ADDENDUM NO. 04

IU Project No. 20240644

BL001 Lowell E. Baier Hall Roof Replacement

A002

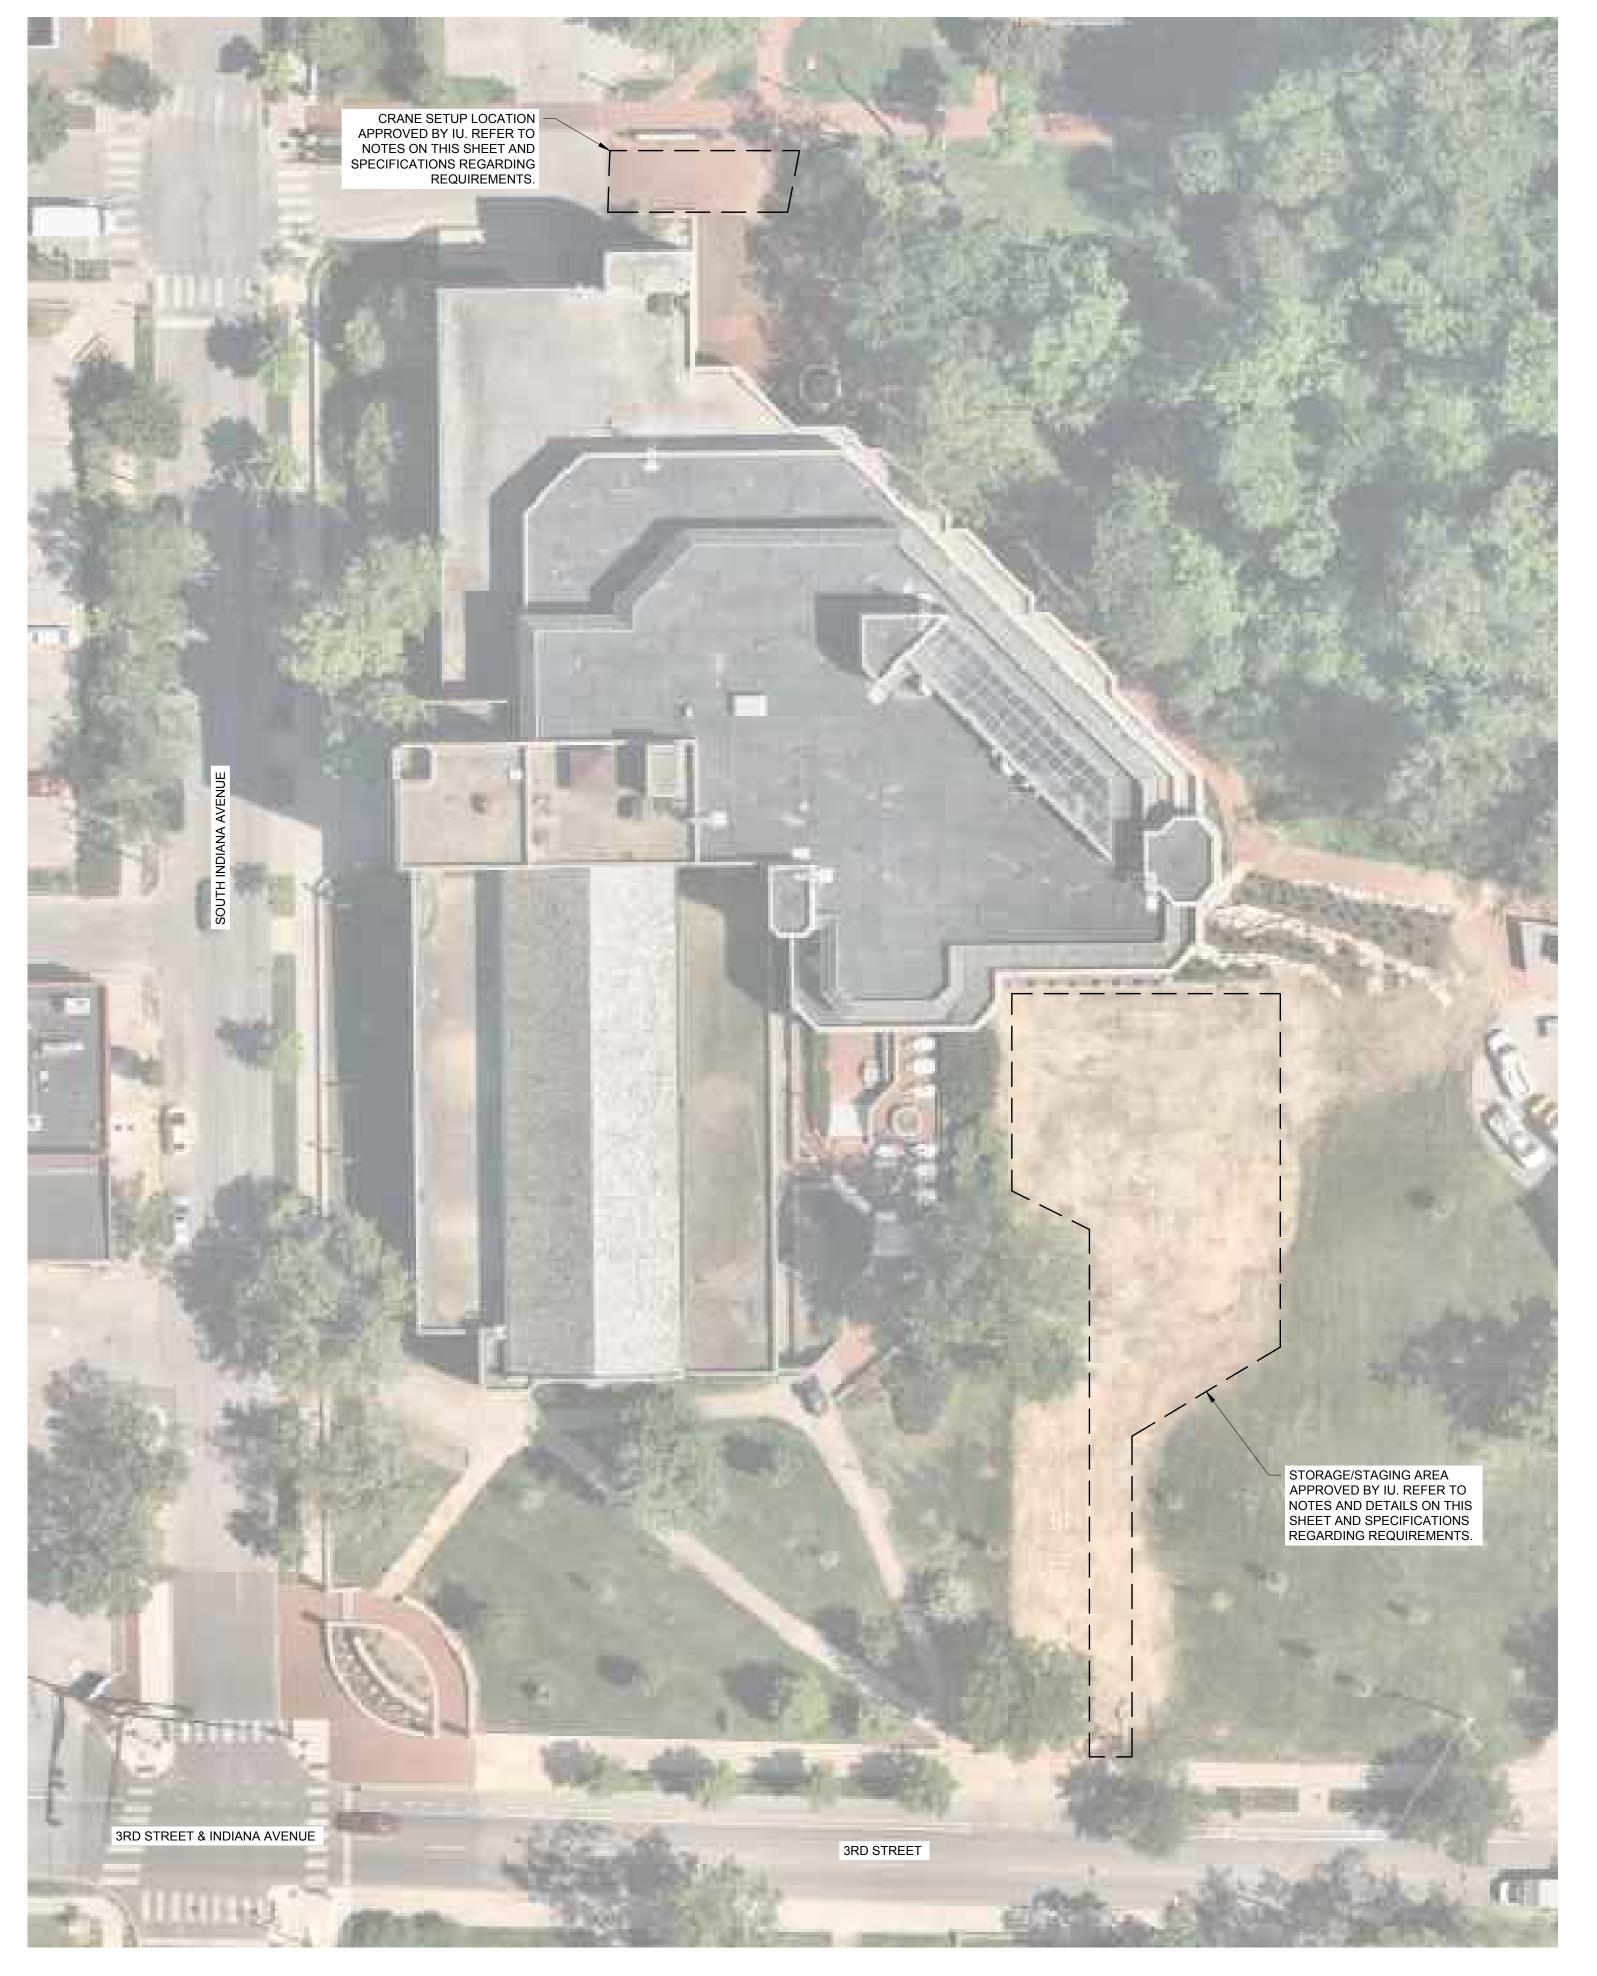
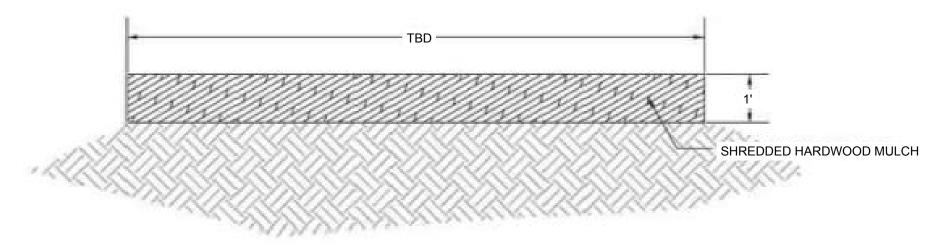
- 1. Updated information regarding the staging/storage area, crane access, and associated requirements is included on the attached, revised sheet A002 and will become part of the full drawing set.
- 2. The Bid Due Date remains 2:00 P.M. Eastern Time, on Thursday, August 21, 2025 (per Addendum No. 03).

- 1. GROUND WITHIN THE STORAGE/STAGING AREA TO BE PROTECTED WITH MULCH PER THE "TYPICAL STORAGE/STAGING AREA GROUND PROTECTION CROSS SECTION" DETAIL ON THIS
- SHEET. SOIL DECOMPACTION IS REQUIRED IN AREAS IN WHICH MULCH IS NOT USED.

2. PROVIDE TEMPORARY TREE PROTECTION PER TYPICAL DETAIL ON THIS SHEET AT THE DRIP
- LINE OF ANY TREES WITHIN THE CONSTRUCTION AREA.

3. ONCE WORK IS COMPLETE, THE DISTURBED AREA SHALL BE SODDED WITH TURF TYPE TALL
- 4. CONTRACTOR TO PROVIDE ANY NECESSARY GROUND PROTECTION AND FENCING FOR CRANE SETUP LOCATION AND CRANE ACTIVITIES.

FESCUE SOD PER 011000 - SUMMARY OF WORK.
